Levy Nuclear Plant, Units 1 & 2

COL Application

Technical Specifications

PLANT SPECIFIC TECHNICAL SPECIFICATIONS (PSTS)

FIGURE 4.1-1 Low Population Zone and Site Boundary Map

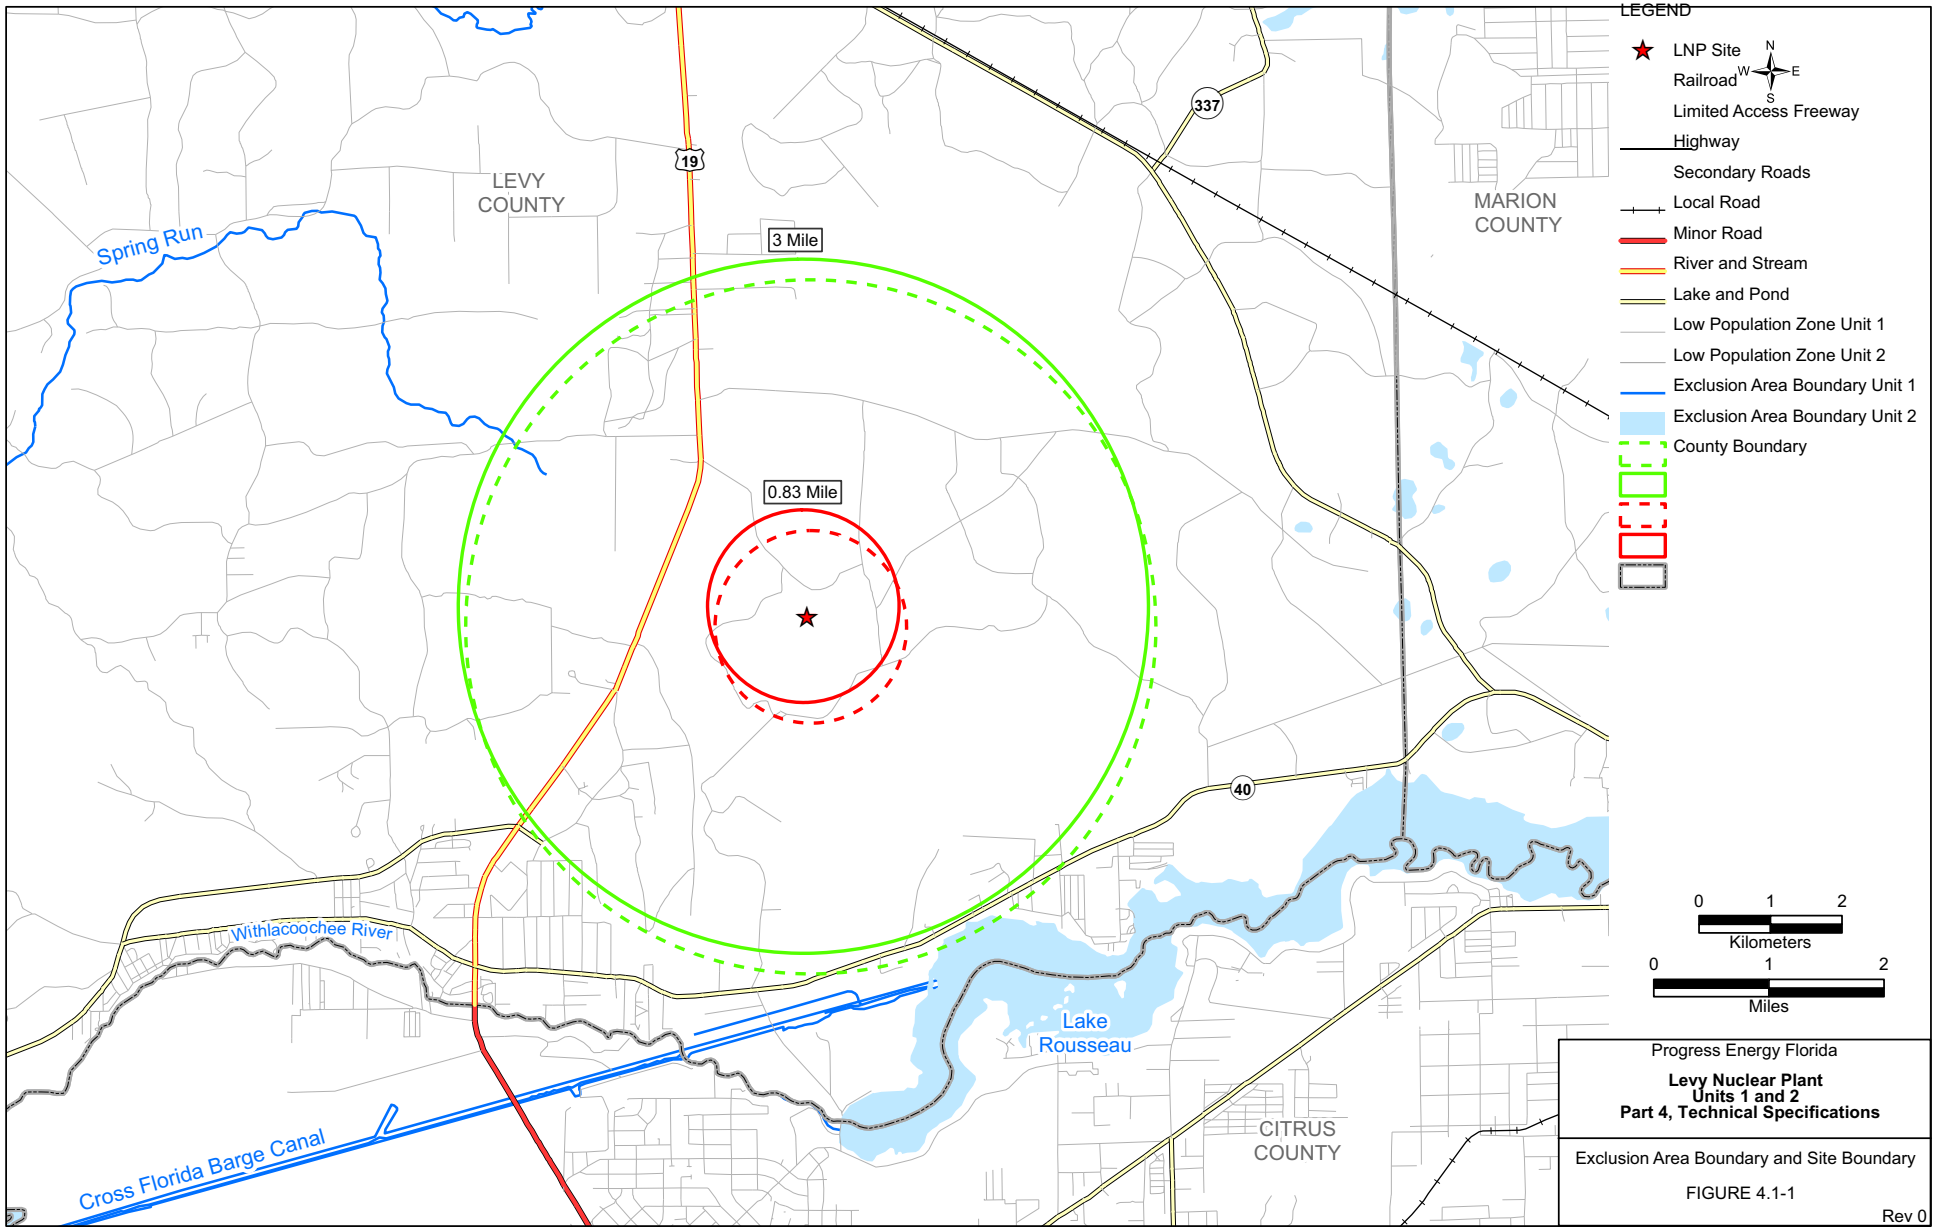
Replace the bracketed information in the GTS with the following:

The Site Boundary is shown in Figure 4.1-1.

Replace the bracketed information in the GTS with the following:
The LPZ is defined by the 3 mile radius from the site center point as shown in Figure 4.1-1.

FIGURE 4.1-2 Exclusion Area Boundary

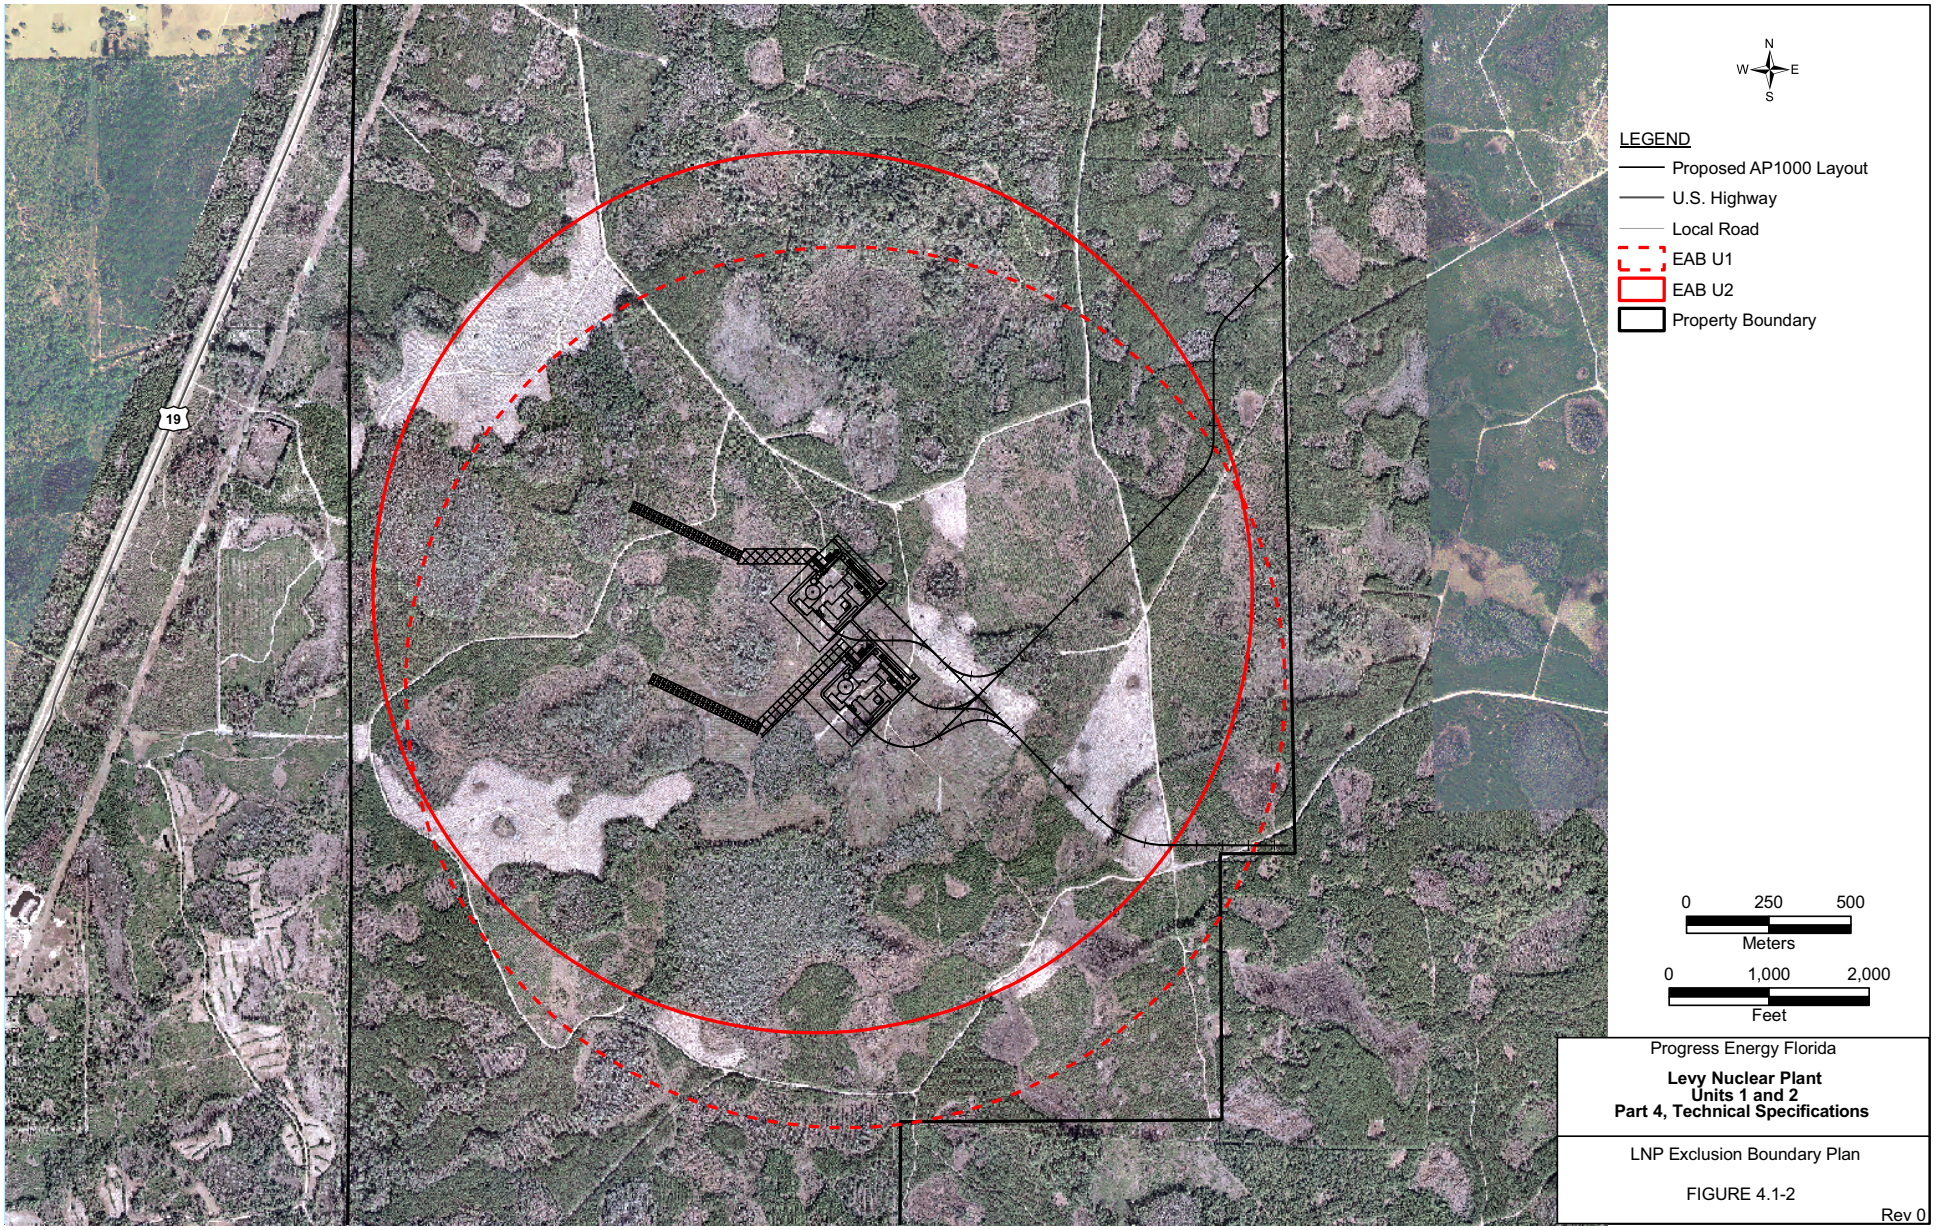
The Exclusion Area Boundary is shown in Figure 4.1-2.

Figure B 3.6.8-1 (page 1 of 1)
Time Prior to Coolant Inventory Boiling

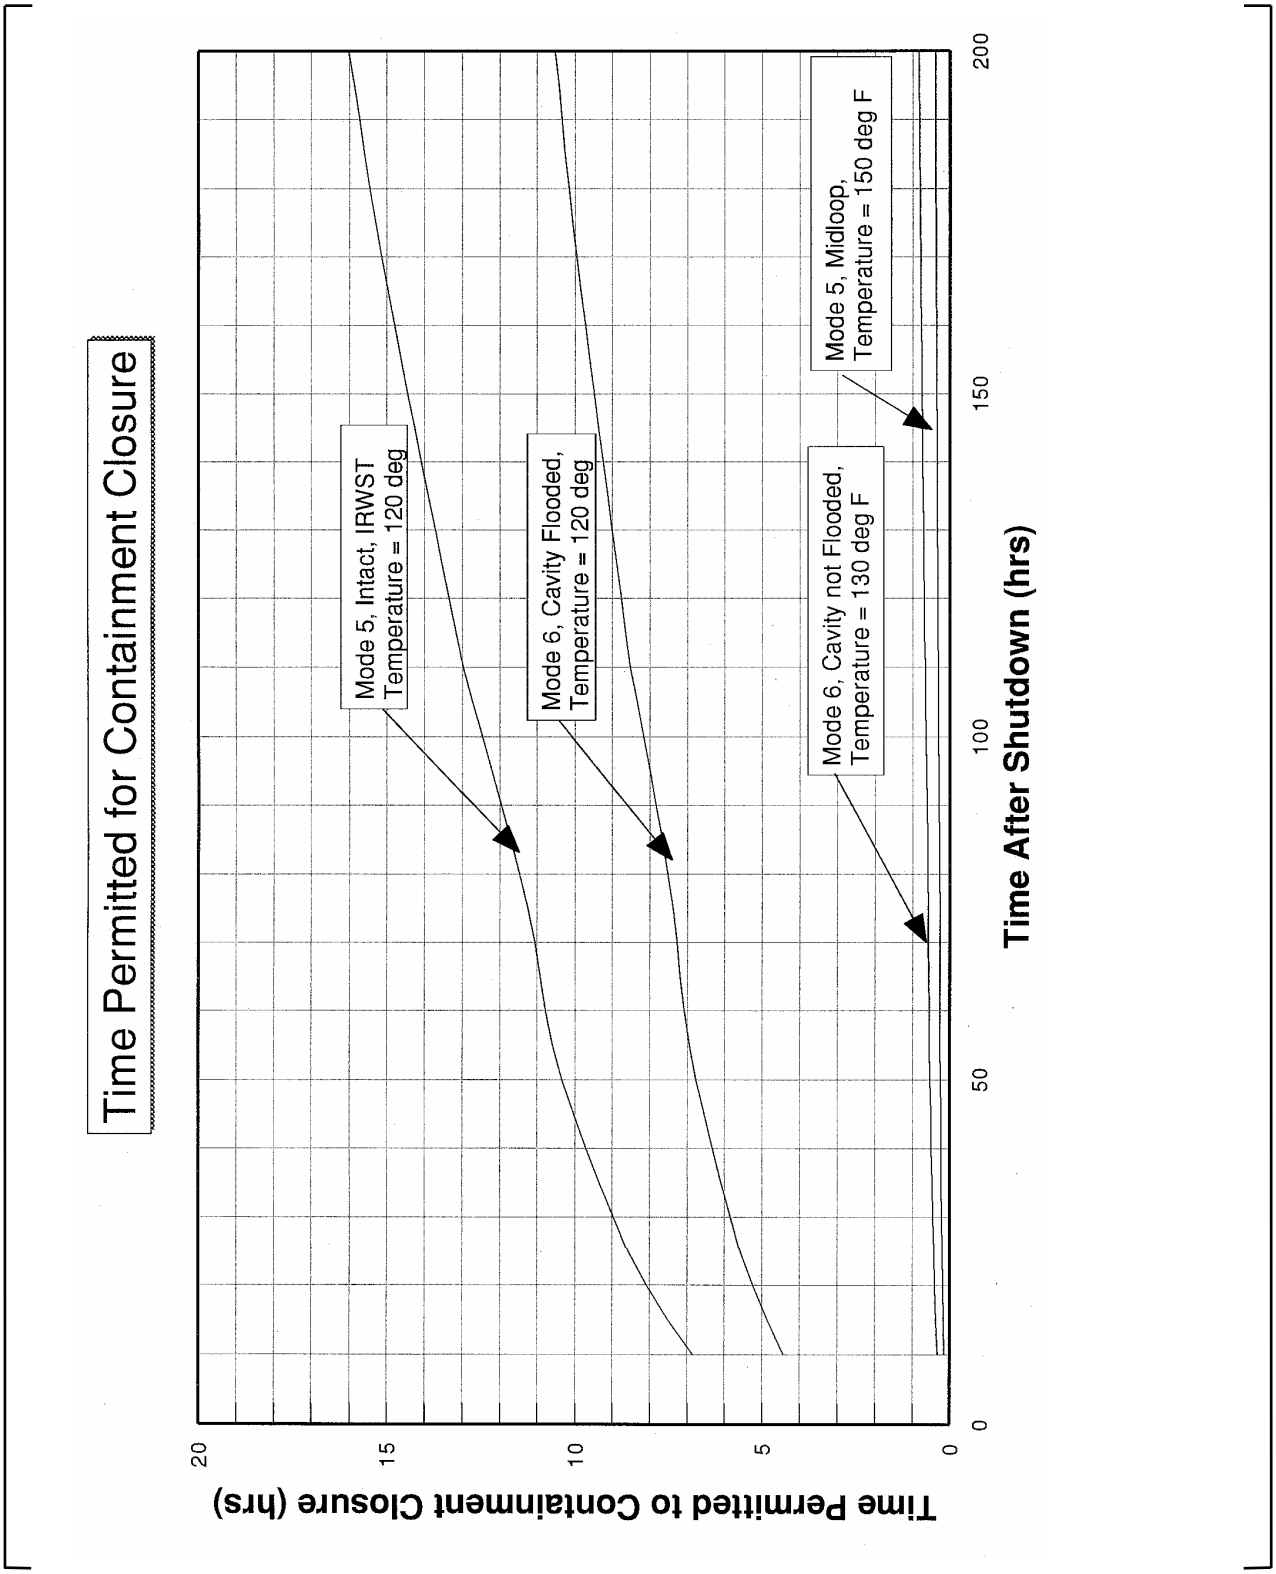
GTS 3.6.8 Bases Figure B3.6.8-1 contains a bracketed curve identifying the time permitted for containment closure in terms of time after shutdown. The entire figure is bracketed. The plant specific curve needed to replace the bracketed value is determined from final fuel data. Therefore, a Bases change is required to provide a plant specific set of curves to replace the bracketed figure. This Bases change will be completed prior to initial fuel load.
